## NSW National Parks and Wildlife Service

Your ref: SSI-70279722  
Our ref: DOC25/810499

Thank you for your referral via the Major Projects Portal regarding the proposed State Significant Infrastructure of the **Mount Piper to Wallerawang Transmission Line** (SSI-70279722). NPWS acknowledges that the project is declared Critical State Significant Infrastructure (CSSI) under Division 5.2 of the *NSW Environmental Planning and Assessment Act 1979* (EP&A Act).

## NPWS detailed advice on the Environmental Impact Statement for the Mount Piper to Wallerawang Transmission Line (SSI-70279722).

Figure 2. Extract from Occupation Permit No. 13612 for the construction of Line 94E.

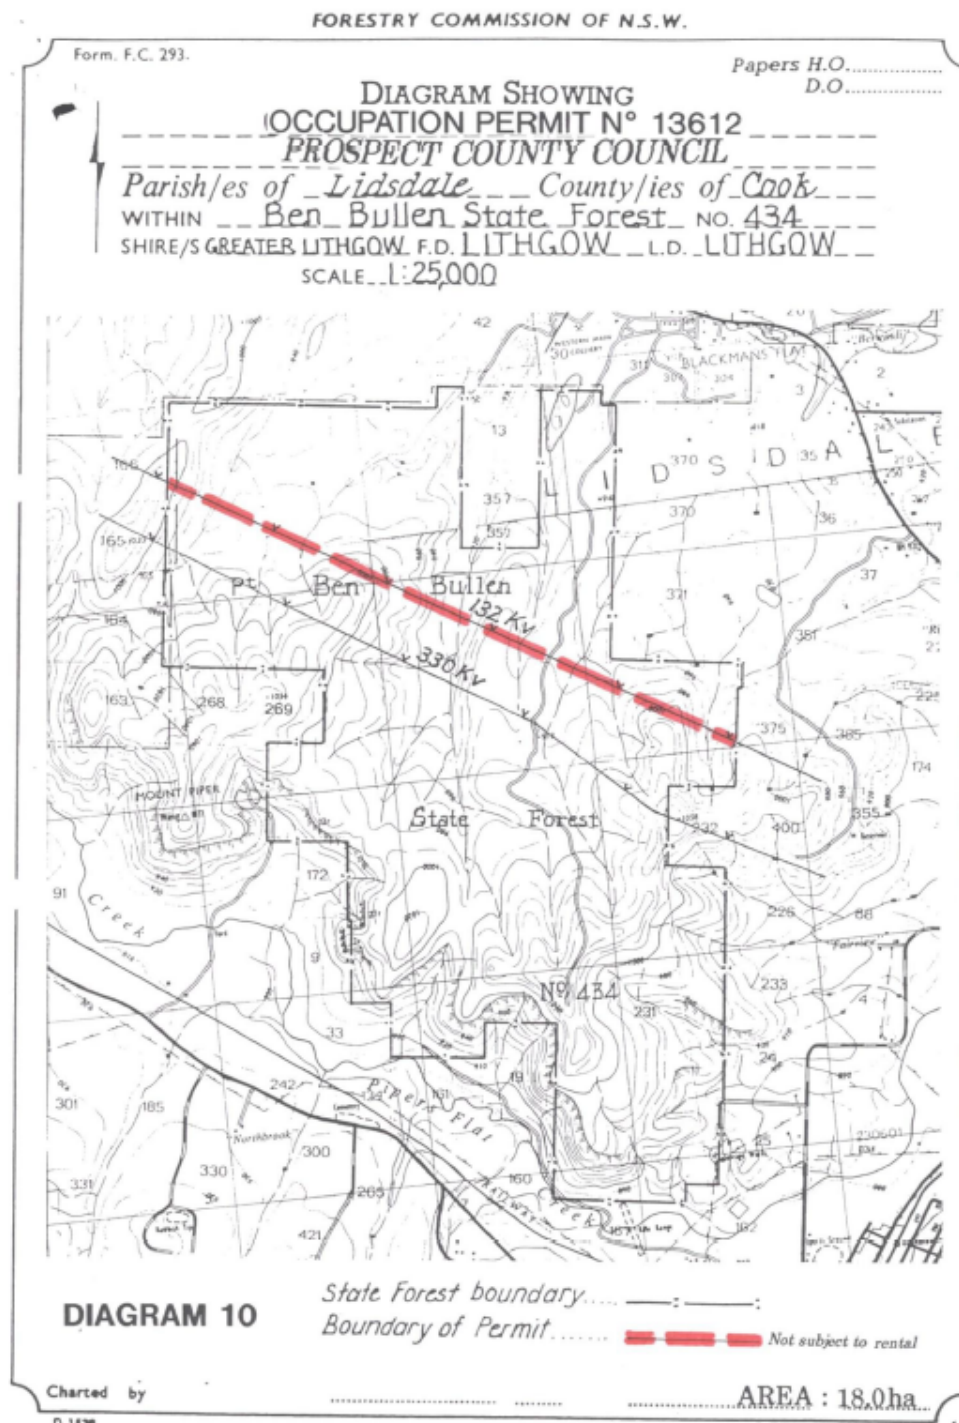
It is confirmed that the substantial works in the park relating to the upgrade of the existing 132kV line (Line 94E), widening of the clearing in the corridor and the access trail associated with this corridor will be subject to an initial construction agreement and then an easement under section 153 of the NPW Act. This will include the access points to the corridor to the east, north and west of the corridor. NPWS queries the area subject to the existing easement for this powerline and the increased area subject to the new easement under the NPW Act. Section 6.2.2 of Technical Report 4 states that the existing easement currently occupies 13.8 ha of the park, and that the increase will be 3.9 ha. NPWS notes that the original occupation permit for the powerline was granted for an area of 18 ha (not 13.8 ha). See **Figure 2**.
